# Access Compliance Report

## Public Rights-of-Way

Intersection ID: 11796	Main Street: N_PINE_ST	Cross Street: W_6TH_ST	Location: S
ADA ID: 02EB6E49ECEC	Ramp Type: Perp	Initial Pass/Fail: Fail	Overall Compliance: No
Severity Score: 13.75			
Codes/Mitigation Info/Possible Solution		Field Measurements/Component Compliance

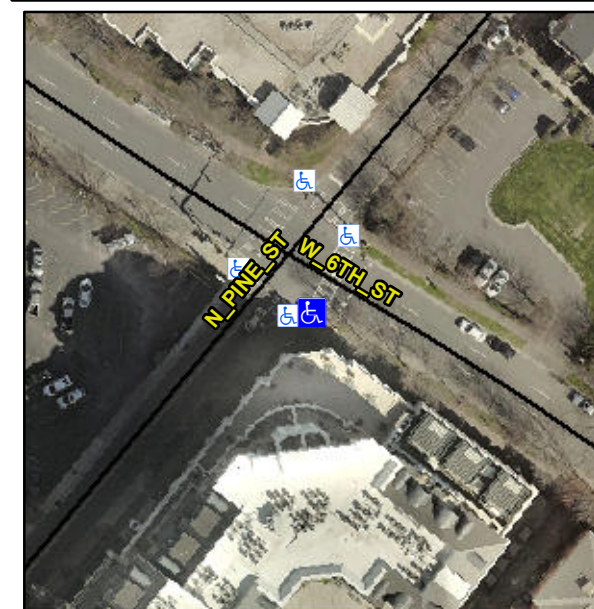
**Not Found, R304.2.2**

Compliance	Description	Data	Compliance	Description	Data
N/A	Ramp Length (in)	60.0	No	Ramp Slope (%)	9.7
Yes	Ramp Width (in)	51.0	Yes	Ramp XSlope (%)	2.2
N/A	Flare Type LT	N/A	N/A	Flare Type RT	N/A
N/A	Flare Slope LT (%)	N/A	N/A	Flare Slope RT (%)	N/A
N/A	Flare Traversable LT?	N/A	N/A	Flare Traversable RT?	N/A
N/A	Landing Length (in)	N/A	N/A	DWS Provided?	N/A
N/A	Landing Width (in)	N/A	N/A	DWS Contrast?	N/A
N/A	Landing Slope (%)	N/A	N/A	DWS Length (in)	N/A
N/A	Landing X Slope (%)	N/A	N/A	DWS Full Width?	N/A
N/A	Landing Curb? (Y/N)	N/A	N/A	DWS Offset (in)	N/A
N/A	Shared Landing?	N/A			
N/A	Gutter Ponding?	N/A	N/A	Gutter Slope (%)	N/A
N/A	Gutter Lip Ht (in)	N/A	N/A	Gutter X Slope (%)	N/A
N/A	Painted X Walk1?	Yes	N/A	Painted X Walk2?	N/A
	X Walk 1 Direction	To NE		X Walk 2 Direction	N/A
N/A	X Walk 1 Width (in)	99.0	N/A	X Walk 2 Width (in)	N/A
	X Walk 1 Slope (%)	0.2		X Walk 2 Slope (%)	N/A
	X Walk 1 X Slope (%)	4.9		X Walk 2 X Slope (%)	N/A

**Remove & Replace Entire Ramp.**
